Kenavon Drive, Reading

Proposed Amendments

West Block and Middle Block Stage 4 Amendments, September 2021

West Block Proposed Amendments Drawing Comparison

Level 2 Plan

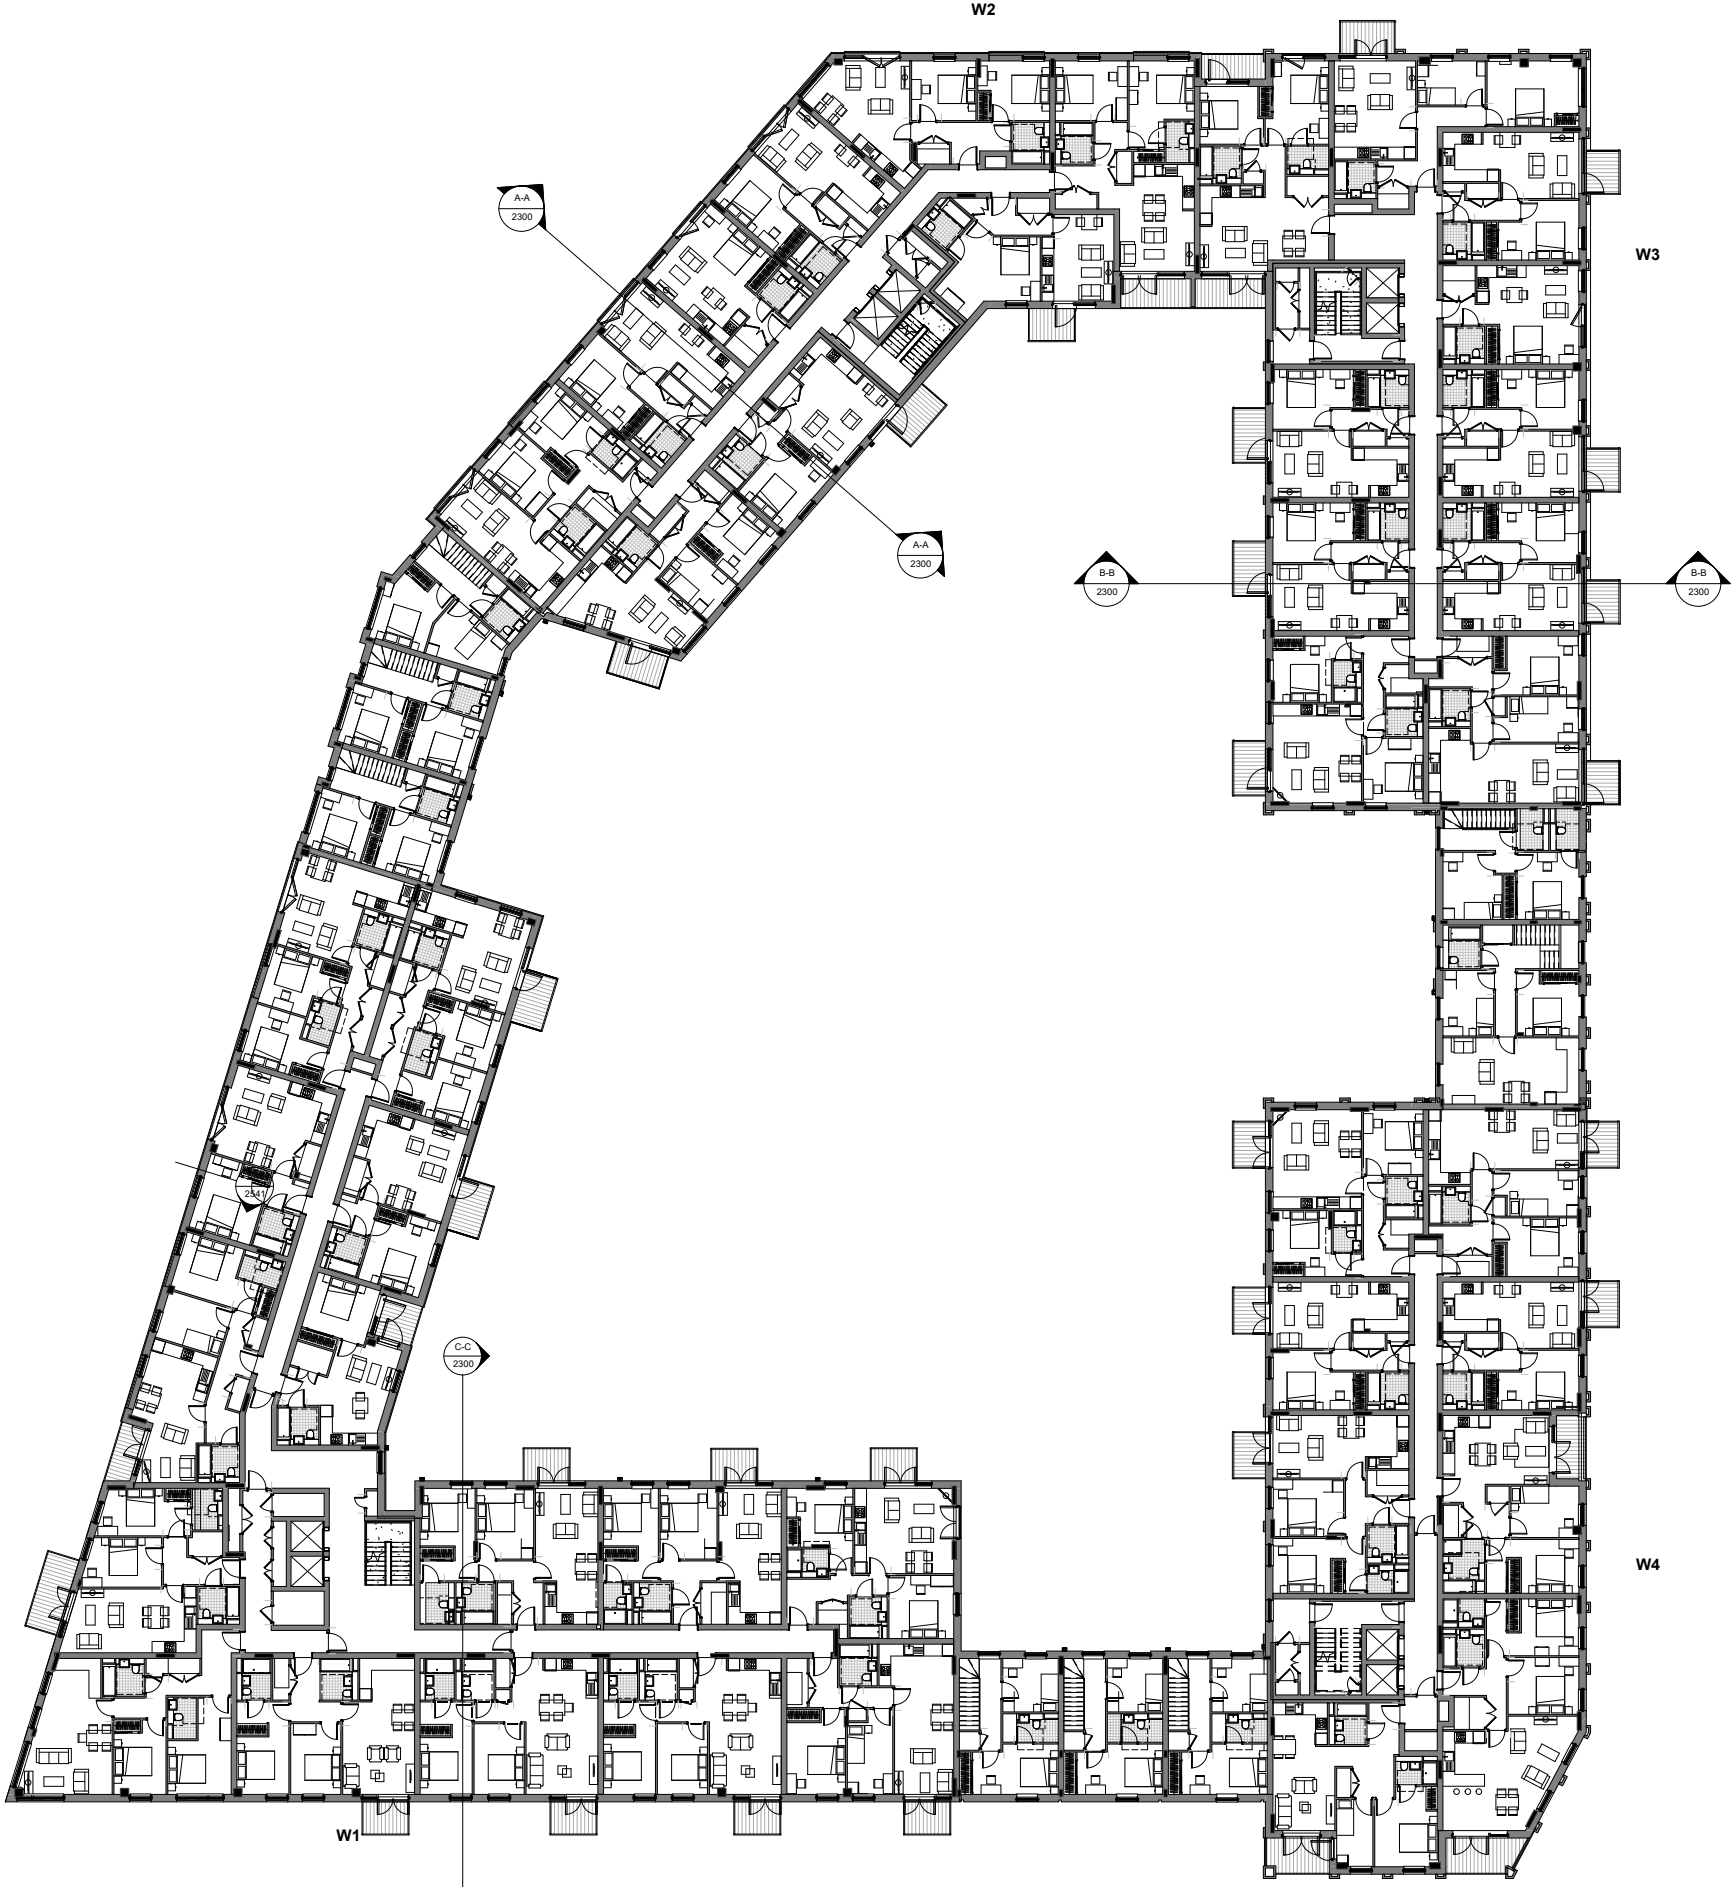
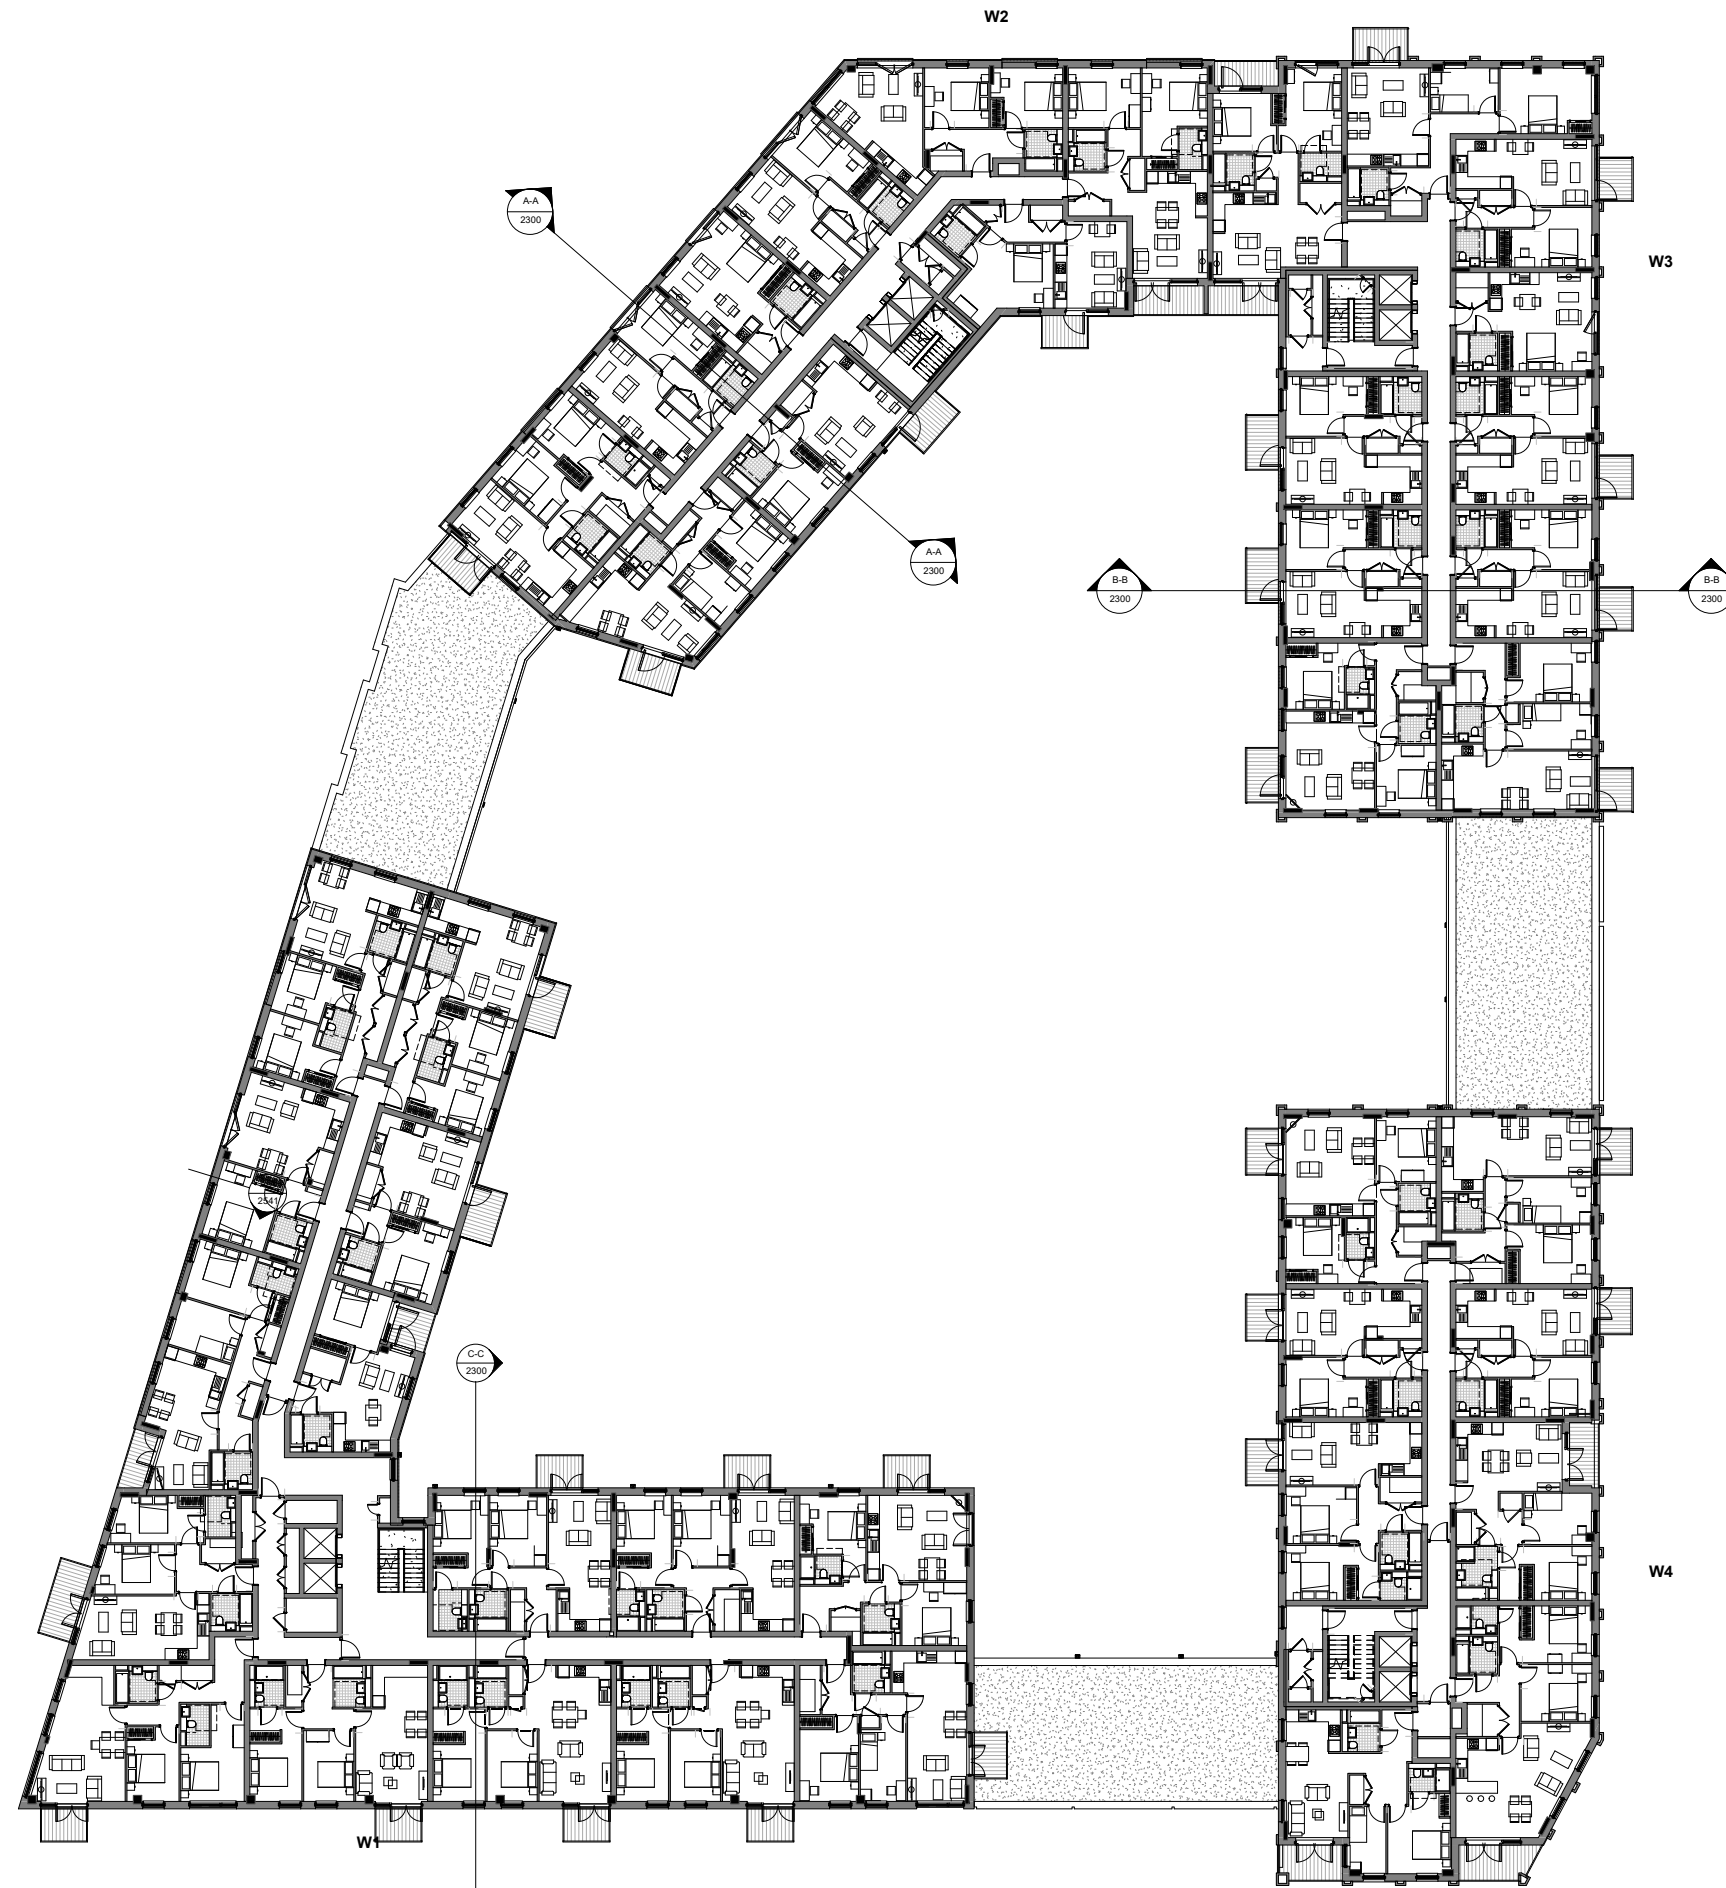
Juliette Door and Panel swapped to allow more space for kitchen countertop run.

Missing Window added to provide daylight and ventilation to bedroom

Balcony Added to give external amenity space in keeping with the elevation

Window Changed to Door

Level 4 Plan

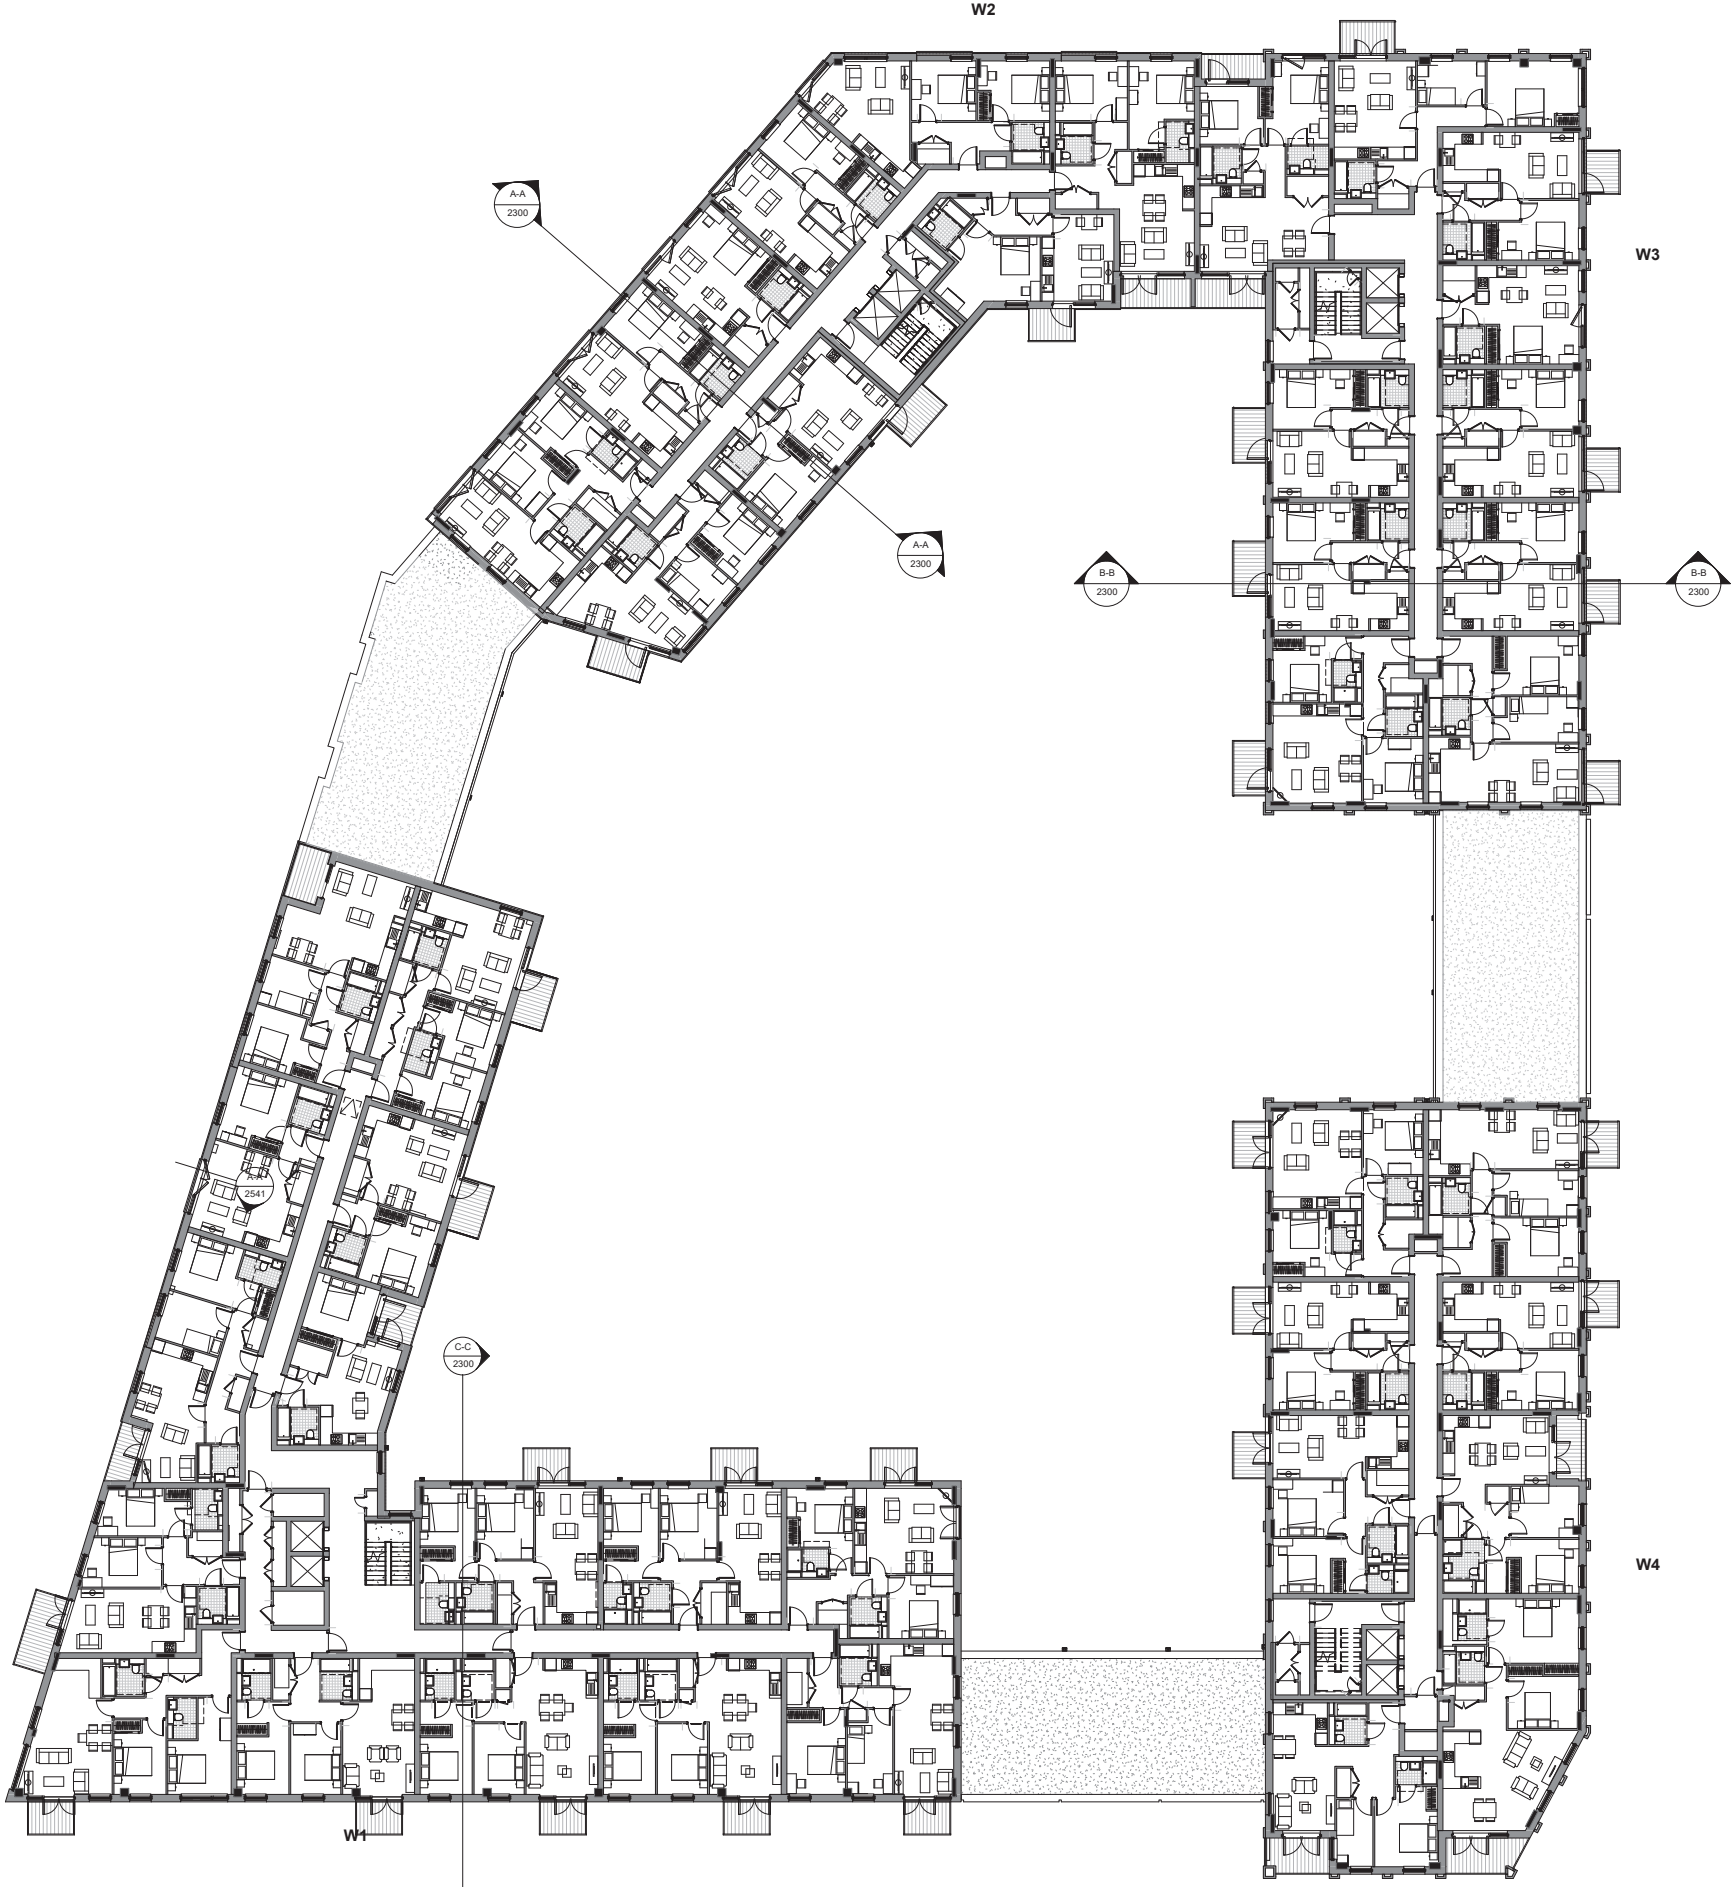
Balcony Added to give external amenity space
in keeping with the elevation
Window changed to Door

Juliette Door and Panel swapped
to allow more space for kitchen
countertop run.
